WASTE MANAGEMENT

Re: Response to Modeling Comments in December 6, 2002, Letter from Miami-Dade Department of Environmental Management, on the Medley Landfill and Recycling Center Flare Permit Application

RE: GEP and Downwash Potential for New Flare at Medley Landfill

FIGURE 2
WASTE MANAGEMENT, INC.
MEDLEY LANDFILL
MEDLEY, FLORIDA
NEARBY BUILDINGS AND DIMENSIONS

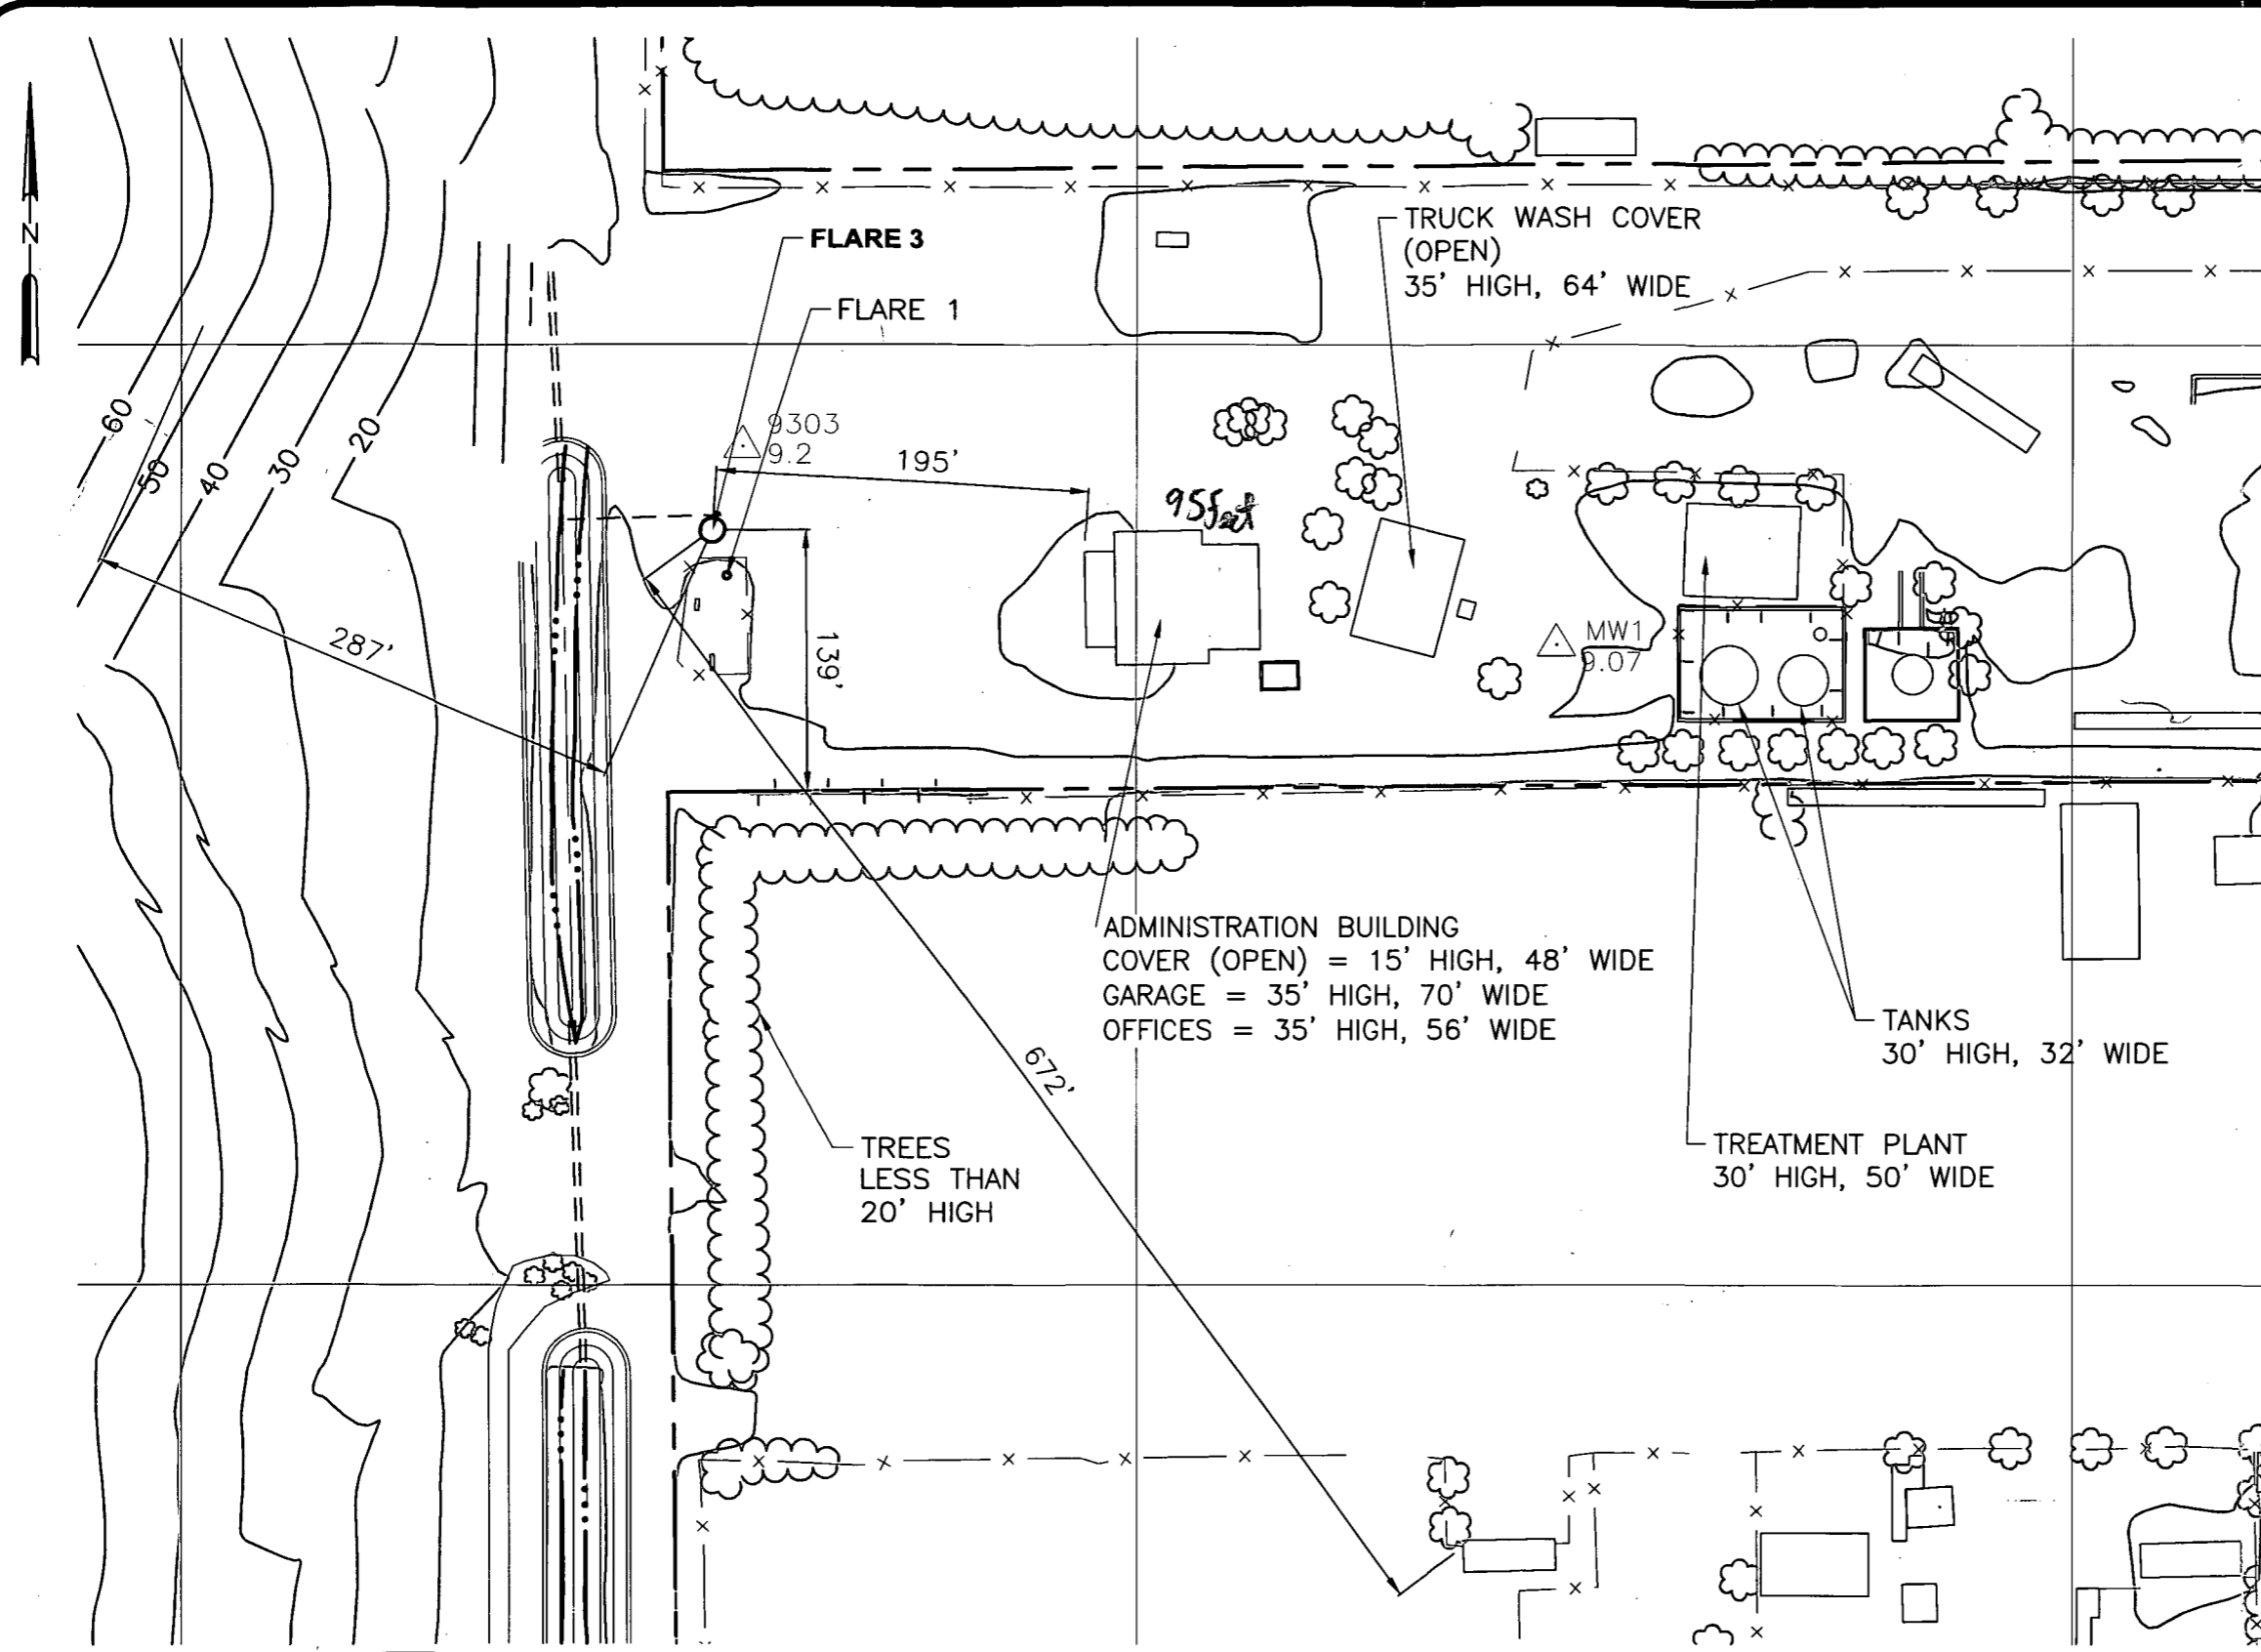
4. Provide adequate information such as the elevations of different structures surrounding the proposed flare, including existing and proposed landfill cells, pine trees, etc. and demonstrate why downwash does not apply in this case.

More complete details of nearby structures near the proposed flare have been included in a revision to the facility plan of the facility in order to more thoroughly evaluate the Good Engineering Practice (GEP) stack height and the potential for downwash.

A chart presenting detailed information and a description of the GEP analysis is included with the revised plan (Figure 2) in Attachment 2.

Figure 2 is a footprint showing all structures considered in the GEP analysis. Table 1 (next page) shows that the flare is far enough away from all buildings/structures such that dimensions do not have to be considered in the modeling.
